37722A-03

S E R V I C E N O T E

HP 37722A Digital Telecom Analyzer

Display flicker not a fault when used in graph storage mode

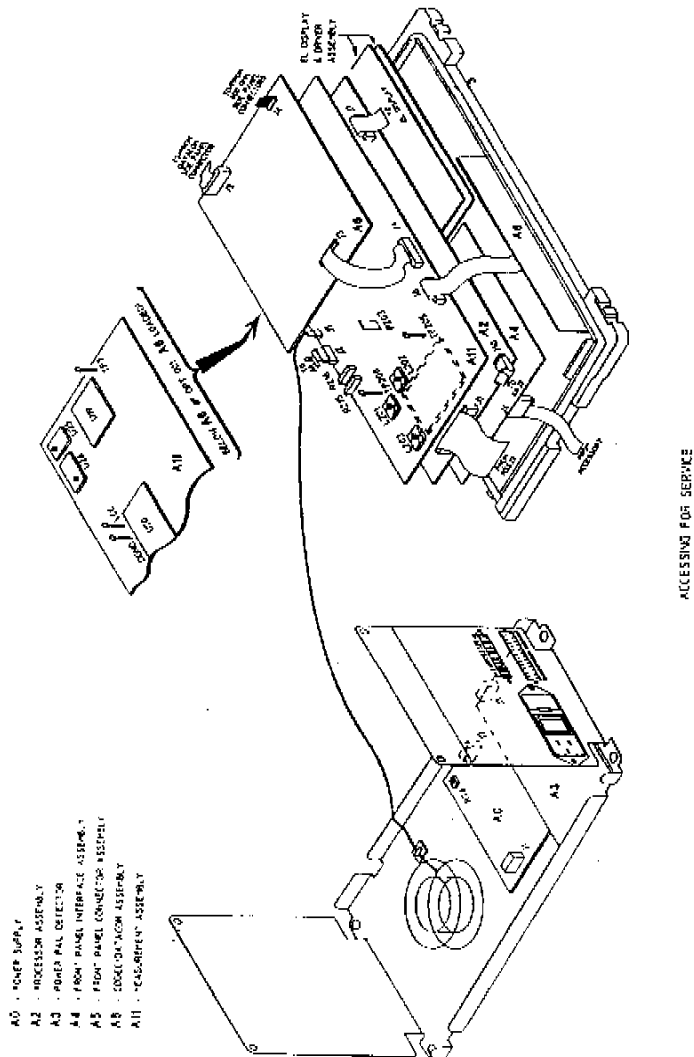
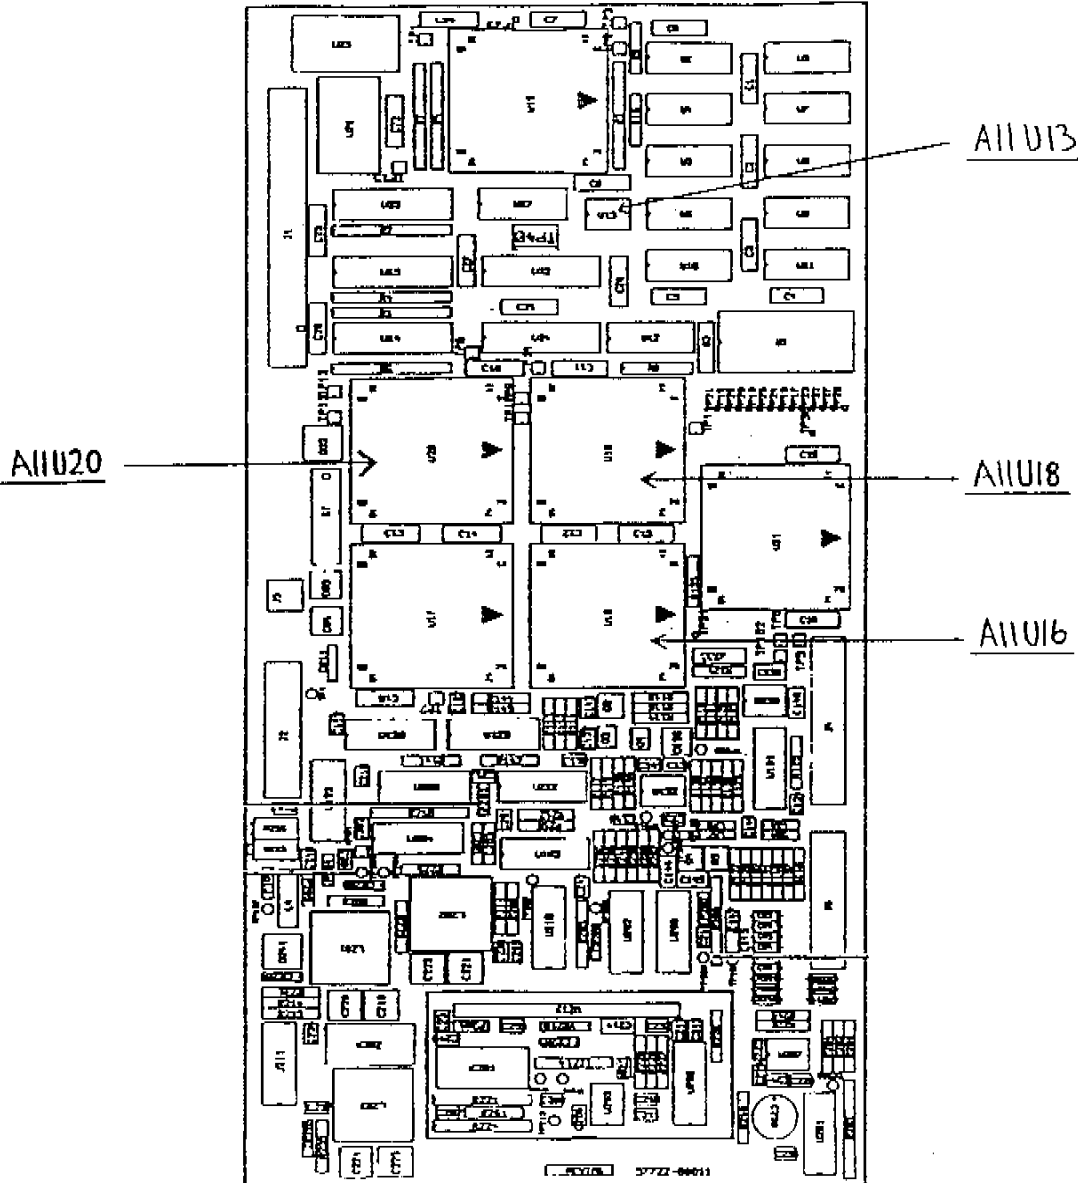
13. Use the A11 Assy Component Location Layout to identify the parts to be replaced (fitted in sockets) and remove the existing A11U16, A11U18, A11U20 and A11U13 - (see illustration of the XILINX devices below), the recommended extraction tool is manufactured by BURNDY and is a QUILEXT- 1 universal extraction tool. If using other than this tool for extraction (ie. a needle like awl) great care must be taken to avoid socket damage.

14. Fit the new XILINX devices (1820-6533) into sockets A11U16, A11U18 and A11U20 (see illustration above for IC orientation) and the new Serial PROM (37722-80010) into A11U13.
15. Fold the A11 Assy back over its connecting ribbon cable.
16. Use the A2 Assy Component Location to identify the parts to be replaced (all fitted on sockets) and remove the existing A2U2, A2U57 and A2U66 parts. A2U66 may already have p/n 37722-80016 fitted. If so, leave existing PROM in place.
17. Fit in the new Proms as follows: A2U2 - 37722-80055, A2U57 - 37722-80057 and A2U66 - 37722-80016.
18. Rebuild the instrument in reverse order.
